**CPED STAFF REPORT**

Prepared for the Heritage Preservation Commission  
HPC Agenda Item #2  
August 11, 2015  
BZH-28757

*Property Location:* 256 1<sup>st</sup> Avenue North/106 3<sup>rd</sup> Street North/  
*Project Name:* Rooftop access and private deck  
*Prepared By:* Aaron Hanauer, Senior City Planner, (612) 673-2494  
*Applicant:* Nicolas Thomley  
*Project Contact:* 612-730-3592  
*Ward:* 3  
*Neighborhood:* Downtown West  
*Request:* To allow for the construction of a rooftop deck and penthouse  
*Required Applications:*

**EXTERIOR ELEVATIONS**

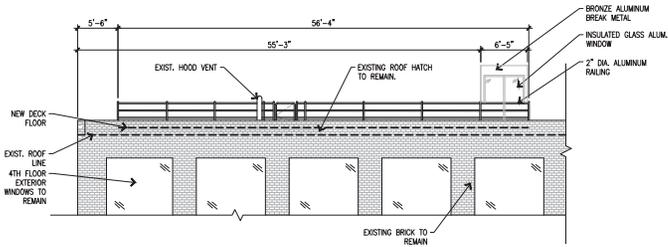
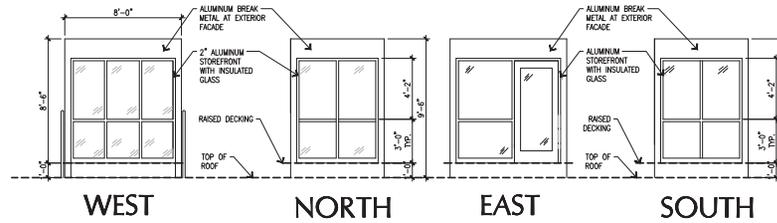
The original building roofline and fifth story was destroyed by a fire in 1958. The applicant's proposal will not impact the existing building's cornice, parapet or other historic elements. However, as proposed, the rooftop deck and railing would be located less than one structural bay and the railing will be visible from the street from most vantage points. The rooftop deck's penthouse and railing will be visible for those viewing the building from 1<sup>st</sup> Avenue North or Washington Avenue North that are looking southwest (see renderings). When viewing the building from 1<sup>st</sup> Avenue North or 3<sup>rd</sup> Street North looking northeast (towards the river), the railing would be visible. The *Minneapolis Warehouse Historic District Design Guidelines* state the following in the Guidelines for Existing Buildings-Rooftop Addition section: "Rooftop additions on buildings that are less than four stories are not allowed due to their visibility. In cases where a rooftop addition is allowed the guidelines are intended to minimize visibility of the addition from the public street by limiting its footprint, scale, height and mass." It is realized that the subject building is narrower than other contributing buildings in the district; however, if the applicant complied with the historic district guideline in having the rooftop deck set back one structural bay, the visibility of the deck railing would not be visible from the 1<sup>st</sup> Avenue North/3<sup>rd</sup> Street North intersection. It should also be noted that if the project complies with the historic district guidelines in terms of having the rooftop deck set back one structural bay from the primary building elevations, the applicant would still be able to build a rooftop deck with 650 square feet of floor area (instead of the 1,314 square feet proposed). Therefore, CPED is recommending that the rooftop deck and railing be set back one structural bay from the primary building elevations (1<sup>st</sup> Street North and 3<sup>rd</sup> Avenue North).

The proposed penthouse will comply with all rooftop addition requirements. It will be set back a minimum of 15 feet from all sides of the building, it will be less than 14 feet in height (9.5 feet in height measured from the existing roof), and the design of the rooftop penthouse, with a dark aluminum break metal and dark bronze aluminum window system will help the penthouse be clearly differentiated from the historic building in a way that does not detract from the character of the historic building or the district.

1. The rooftop deck and railing shall be set back one structural bay from the primary building elevations (1<sup>st</sup> Street North and 3<sup>rd</sup> Avenue North).
